**STAFF REPORT** 12-11-2019 MEETING  
**APPLICATION NUMBER:**19-6586  
**ADDRESS:** 2001 PARK AVENUE  
**HISTORIC DISTRICT:** GRAND CIRCUS PARK  
**APPLICANT:** BRIAN REBAIN  
**DATE OF COMPLETE APPLICATION:** 12/4/2019  
**DATE OF STAFF SITE VISIT:** 12/4/2019

**SCOPE:** REHAB BUILDING

Sheet Title  
**WINDOW  
ELEVATIONS AND  
SCHEDULE**

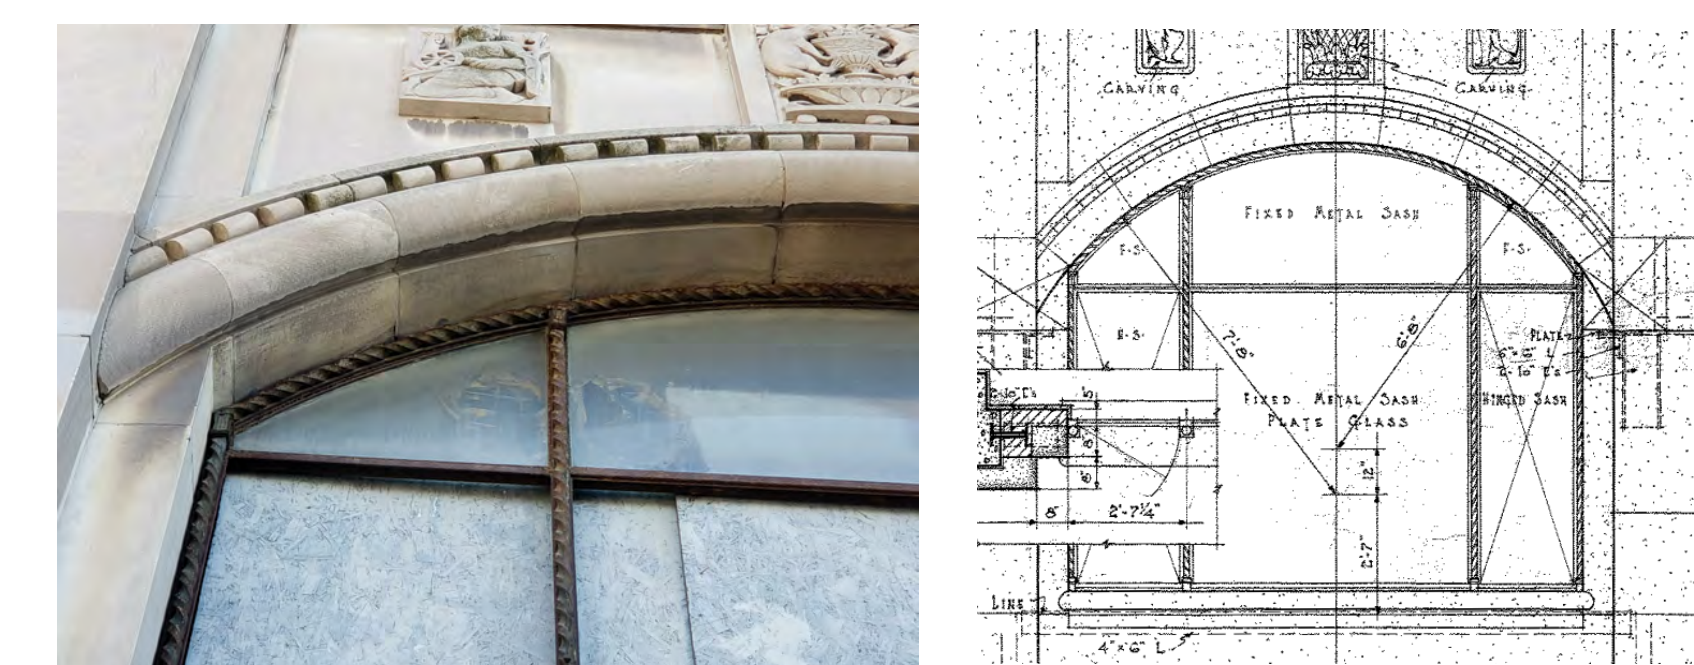
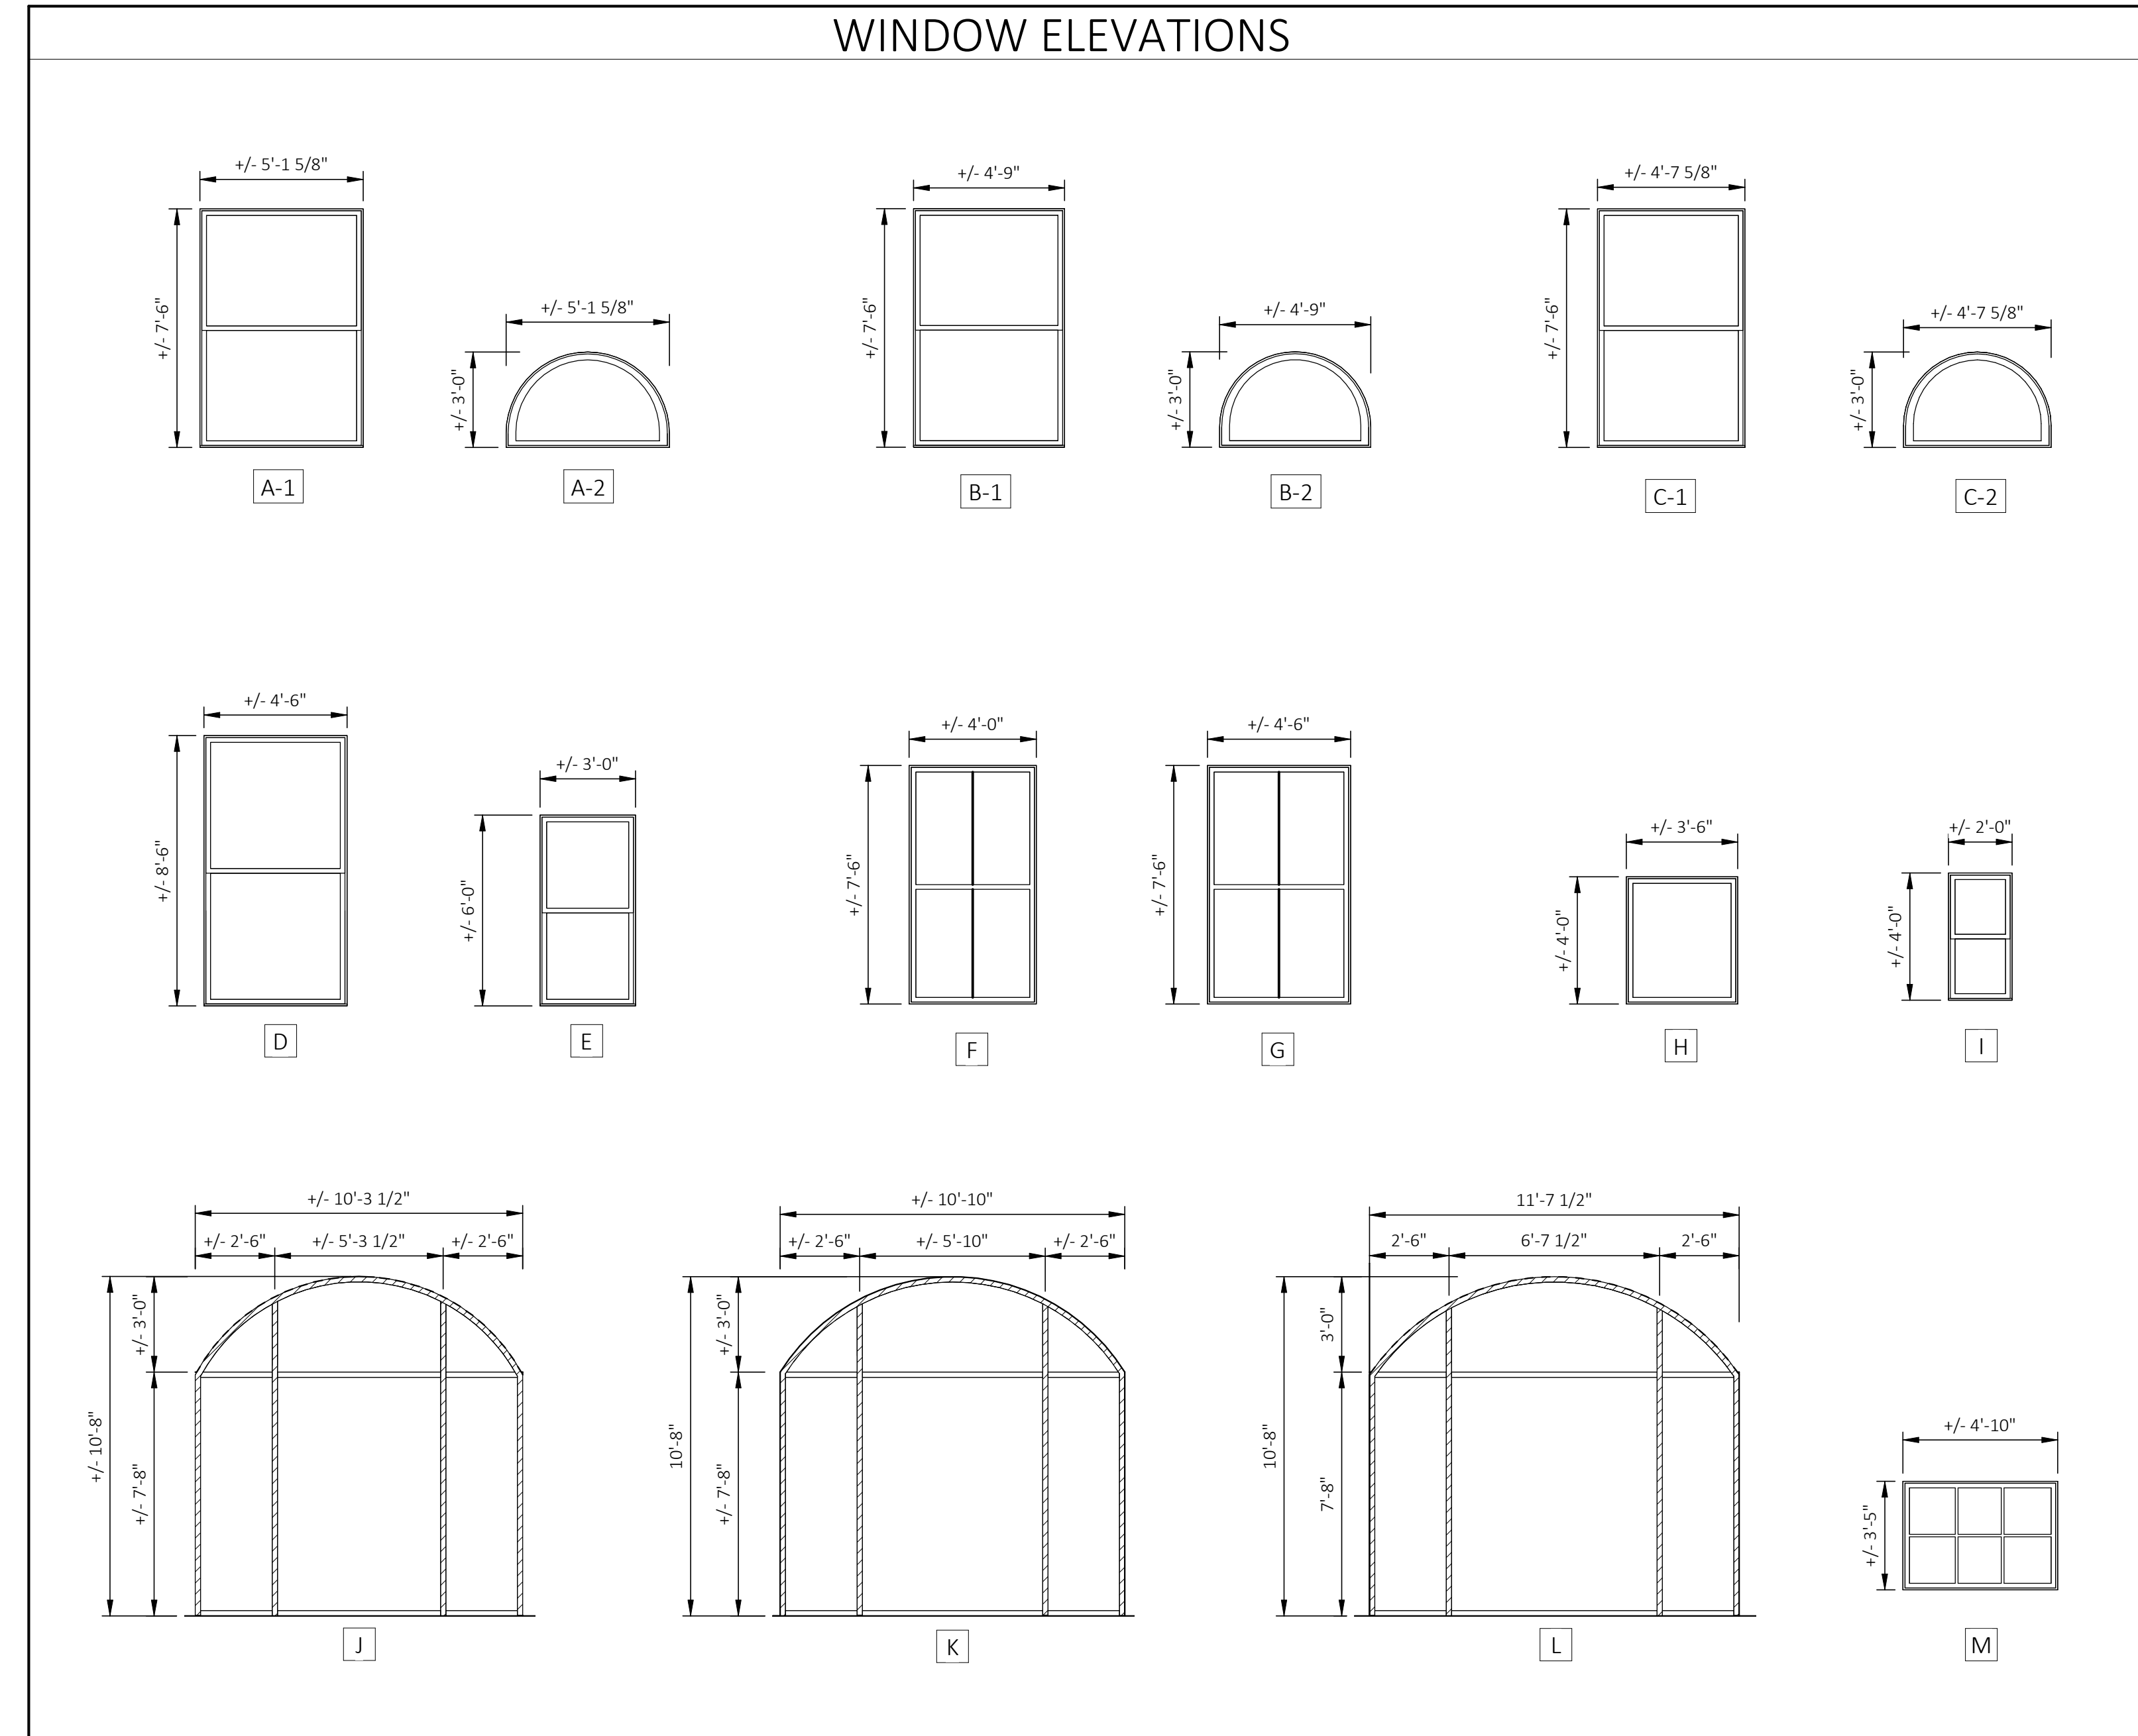
- See the provided details of the existing vs the proposed for the new windows. It does not appear clear to staff the new windows will closely replicate the detail of the existing

- All new replacement windows shall match the old in dimension and detailing to include the lugs, muntins, head, sill, panes, jambs, sash, and overall depth. The applicant shall provide details of the existing and proposed windows which clearly demonstrate that the new windows adequately match the design and detailing of the old to HDC staff for review and approval. If staff determines that the new windows do not adequately replicate the old, they will forward the work item to the Commission for review at a future meeting
